**Waterfront Barry,
Vale of Glamorgan**

Stage 1 Road Safety
Audit

March 2010

Ove Arup & Partners Ltd

3.5 Y Rhodfa / Clos Tyniad Glo / Ffordd y Mileniwm (TA Junction 19, Figure 7.18)

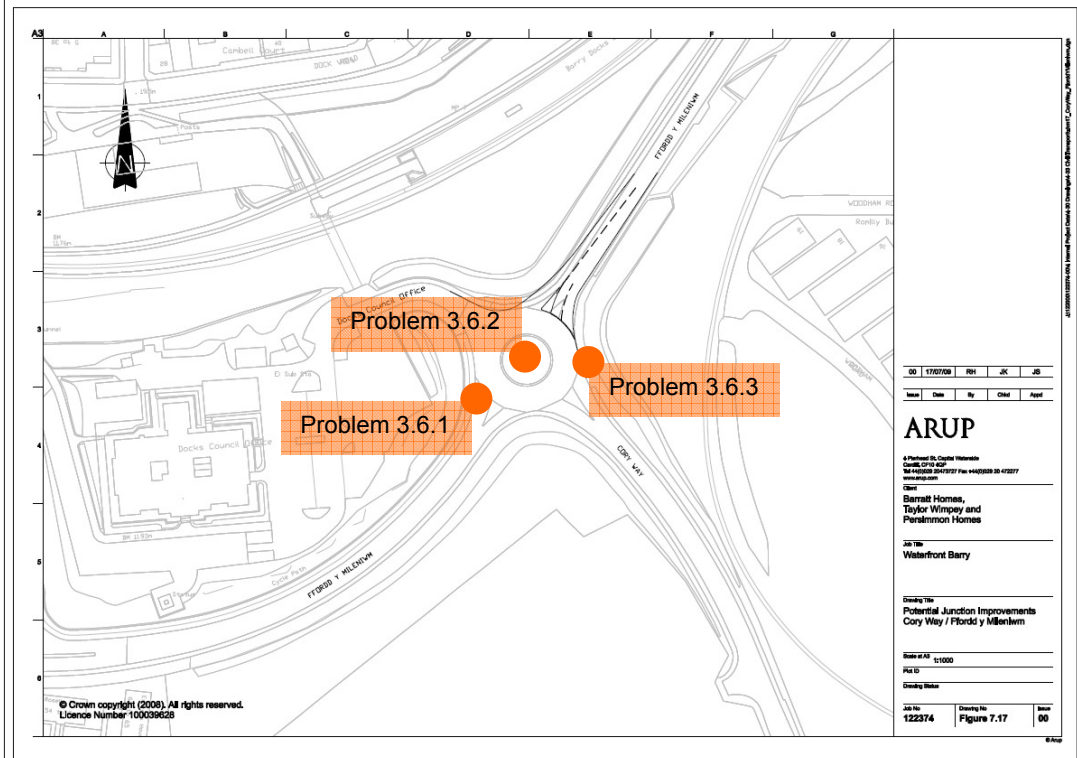
Description There is an excessive amount of vegetation and hard landscaping on the circulatory island of the roundabout.

Description The widening of the road to the south on the approach to the junction will increase forward visibility.

The proposed alteration to the junction layout results in an increase in the deflection radius from westbound Ffordd y Mileniwm.

Recommendation Remove the vegetation and hard landscaping from the roundabout

Review the junction layout to ensure sufficient entry deflection is provided to minimise entry speeds.

Alter the junction layout in order to provide sufficient entry deflection.

3.6 Cory Way / Ffordd y Mileniwm (TA Junction 17, Figure 7.17)

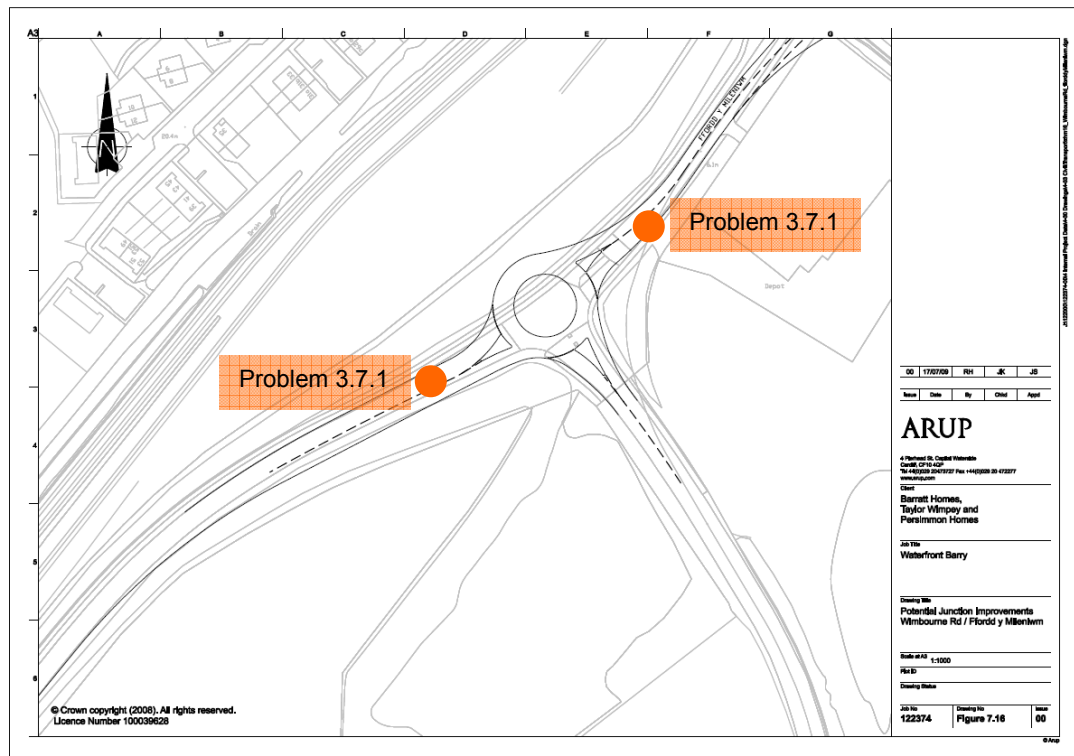
The proposed alteration to the junction layout results in an increase in the deflection radius for northeast bound traffic.

There is an excessive amount of vegetation on the circulatory island of the roundabout

Description There is no footway around the eastern side of the junction, between the north side of Ffordd y Mileniwm to the east side of Cory Way.

Alter the junction layout in order to provide sufficient entry deflection.

Recommendation Remove the vegetation.

Recommendation Extend the footway on the eastern side of Cory Way to Ffordd y Mileniwm and provide an appropriate pedestrian crossing point on Ffordd y Mileniwm.

3.7 Wimbourne Road / Ffordd y Mileniwm (TA Junction 16, Figure 7.16)

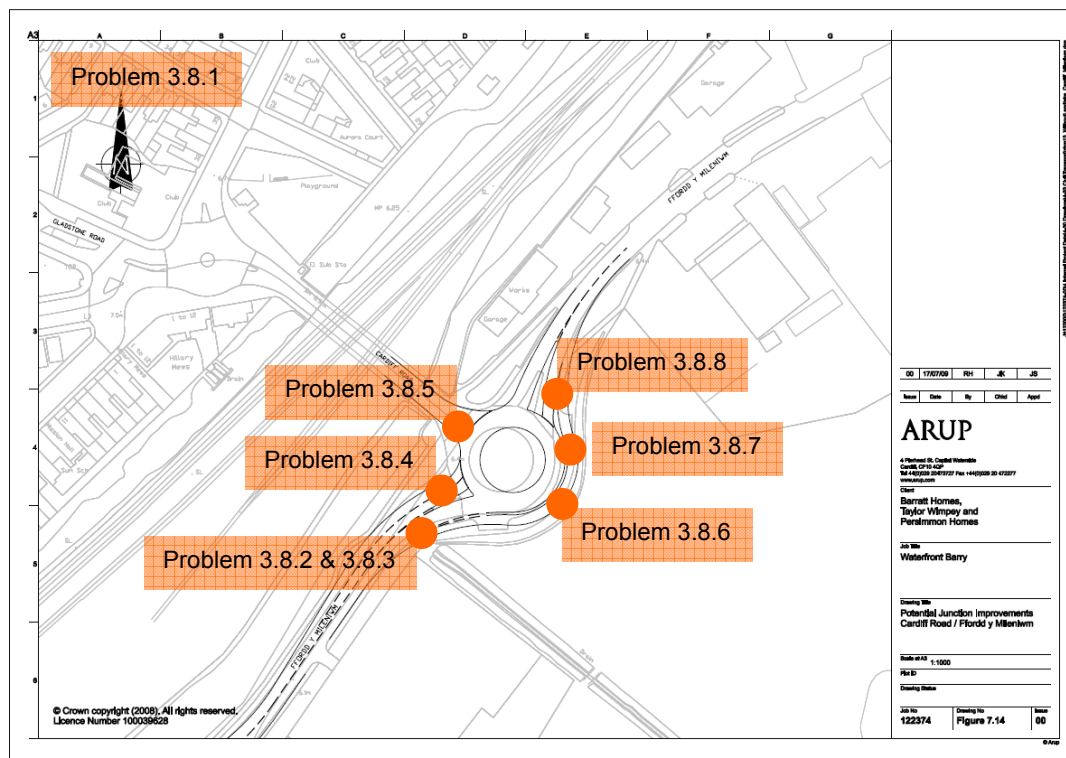
The Ffordd y Mileniwm / Wimbourne Road junction is located on a grade 150m inside a 40 mph speed limit.

The junction location is likely to result in high approach speeds on Ffordd y Mileniwm, especially northeast bound traffic. This could lead to over-running the give-way line.

Extend the 30 mph speed limit to the west of the junction and introduce speed reducing measures on Ffordd y Mileniwm on the approaches to the junction.

3.8 Cardiff Road / Ffordd y Mileniwm (TA Junction 13, Figure 7.14)

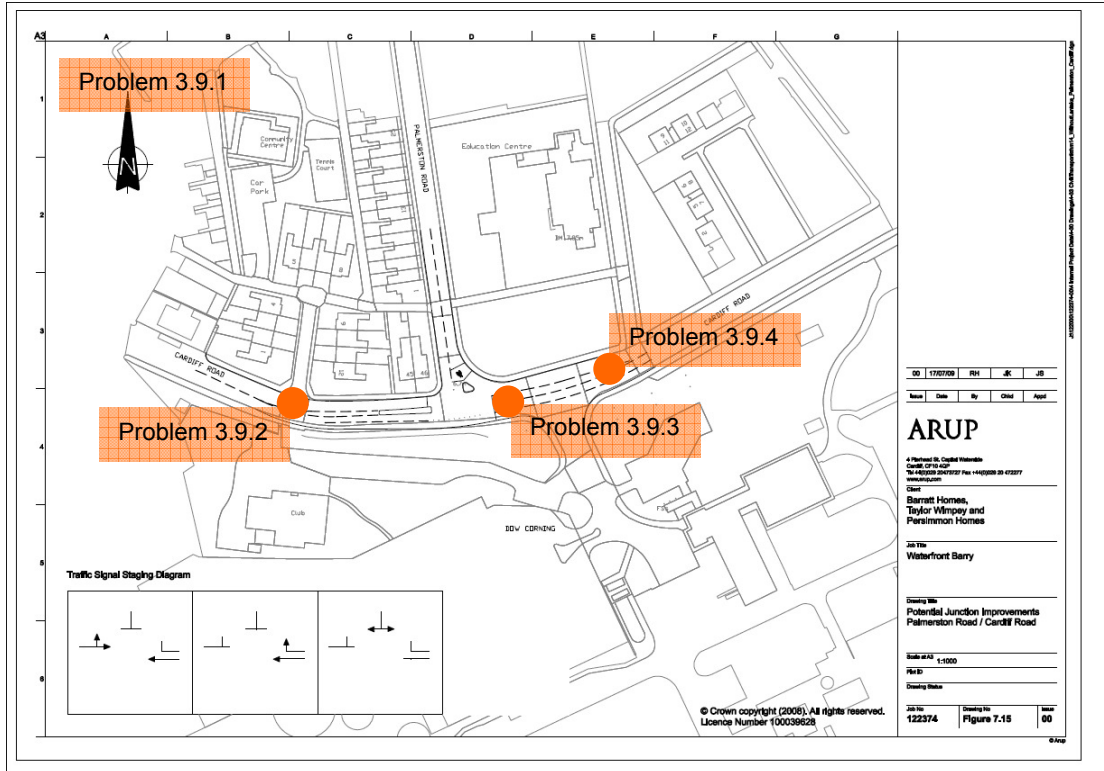
Description A number of the traffic lanes proposed at the junction are narrow (less than 3.0 metres).

Description It is not clear from the proposals as to which traffic stream will have priority at the downstream merge of the south west bound slip lane and Ffordd y Mileniwm.

Description The proposed slip lane merge would occur coincident with an existing pedestrian crossing point to the southwest of the junction.

The proposed alteration to the junction layout results in an increase in the radius of deflection for traffic approaching on Ffordd y Mileniwm

The exit lane from the roundabout to Cardiff Road is situated immediately after the Ffordd y Mileniwm entry arm. The location of the splitter island results in a narrow exit lane.

Description Welsh Water has a permanent access to the land to the southwest of the junction.

Description The south westbound slip lane proposed for the roundabout is excessively bendy with a 3.5 metre lane

Description The proposed slip lane crosses an existing pedestrian crossing point immediately west of the southwestbound diverge point.

Recommendation Provide consistent lane widths, able to accommodate all types of traffic.

Recommendation Provide appropriate road markings at the merge.

Relocate the pedestrian route away from the merge.

Alter the junction layout in order to provide sufficient entry deflection.

Ensure the exit lane can accommodate all types of traffic.

Recommendation Provide an alternative access for utilities.

Recommendation Provide appropriate lane widening on tight radii to accommodate larger vehicles.

Recommendation Ensure there is an appropriately sized refuge between the traffic streams at the crossing, and that pedestrians are aware of the road layout.

3.9 Cardiff Road / Palmerston Road (TA Junction 14, Figure 7.15)

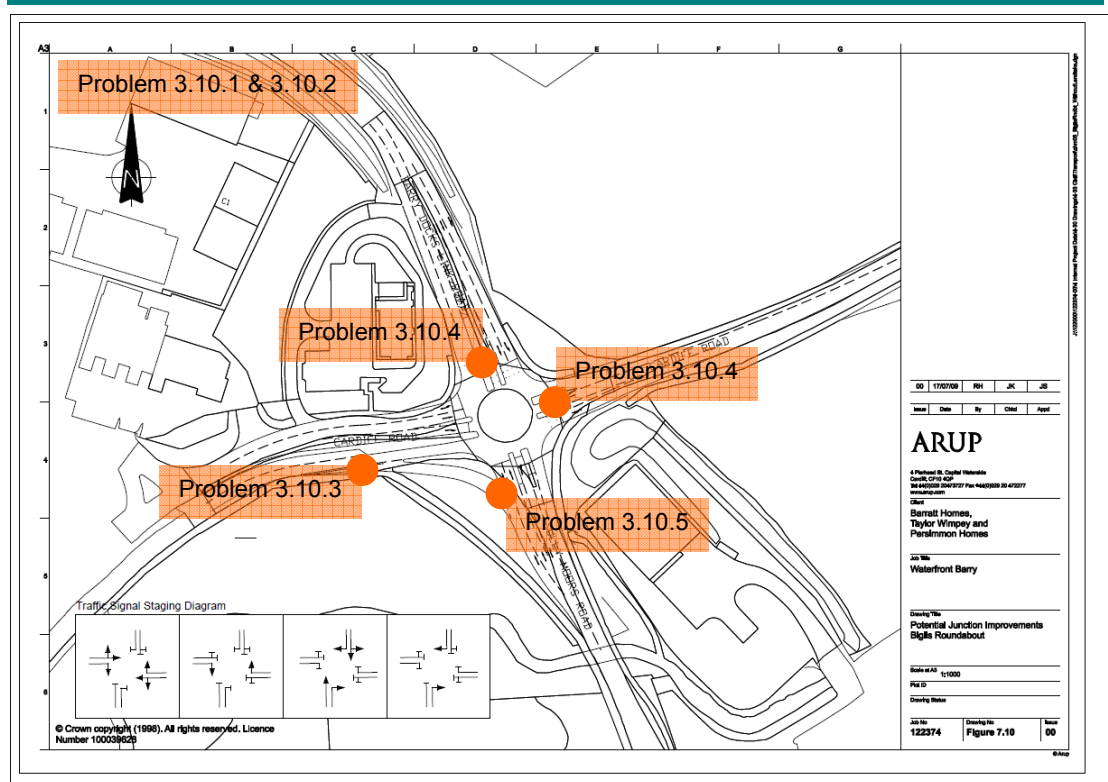
Description The proposed junction omits the existing advanced cycle stop lines provided on Cardiff Road at the junction, which is located on National Cycle Route 88.

Edmund Place on the north side of the Cardiff Road is located such that vehicles waiting to turn right into the road would have to wait within the westbound exit merge.

The nearside westbound lane of Cardiff Road is incorrectly shown with a 'straight on and left' arrow at the junction with Palmerston Road.

The proposed junction affects the removal of the existing refuge on Cardiff Road to the east of the junction. No pedestrian facilities are proposed at the revised junction.

Recommendation Replace the cycle stop lines.

Alter the proposed road layout in order to provide a right turning pocket for Edmund Place.

Provide a straight on arrow in the nearside lane.

Provide pedestrian facilities at the junction.

3.10 Sully Moors Road / Cardiff Road / A4231 Barry Docks Link Road (TA Junction 5, Figure 7.10)

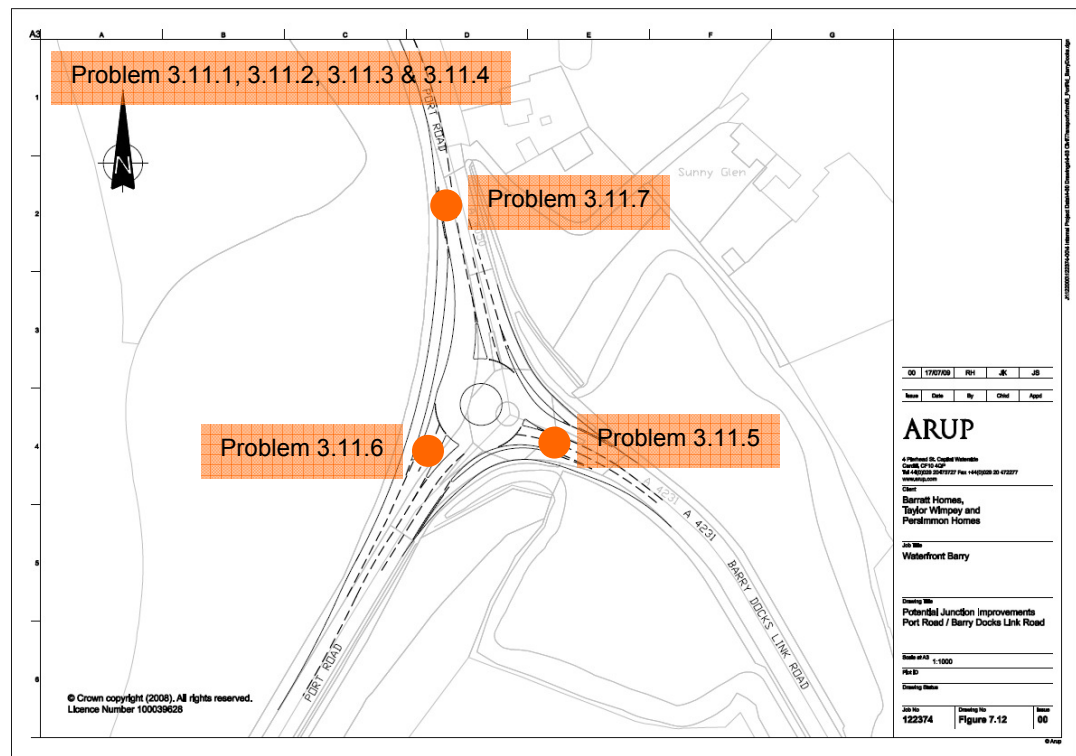
Description The proposed junction makes no provision for cyclists but it is located on National Cycle Route 88.

Description It would appear from the junction layout that larger vehicles turning at the junction will foul the proposed splitter island positions.

Location	Cardiff Road (west)
Summary	Relocation of bus stop
Description	The proposed Left Turn Slip Lane (LTSL) from Sully Moors Road to Cardiff Road would require the relocation of the existing bus stop on Cardiff Road.

Location	Barry Docks Link Road and Cardiff Road (east)
Summary	Staggered pedestrian crossings
Description	The proposals show right-left staggered pedestrian crossings on the northern and eastern arms of the junction. The right-left stagger results in pedestrians approaching the second half of the crossing, facing away from oncoming traffic. This could result in a pedestrian continuing to cross, oblivious to oncoming traffic.
Recommendation	Provide the crossings with a left-right stagger.

Location	Sully Moor Road
Summary	Access to Left Turn Slip Lane (LTSL)
Description	The LTSL from Sully Moors Road to Cardiff Road diverges close to the stop line. The proposed diverge location provides limited storage for traffic moving ahead before the LTSL becomes blocked, limiting its effectiveness, leading to driver frustration which could lead to vehicles using the verge to access the lane placing pedestrians and other road users at risk.
Recommendation	Lengthen the LTSL from Sully Moors Road allowing traffic to diverge earlier, reducing queuing and driver frustration on this approach.

Recommendation Include measures to assist cycles at the junction.

Recommendation Undertake an AutoTrack assessment of the junction to ensure all turning manoeuvres are possible by larger vehicles.

Recommendation	Ensure the bus stop is relocated so as to avoid undue influence on the LTSL merge.
-----------------------	--
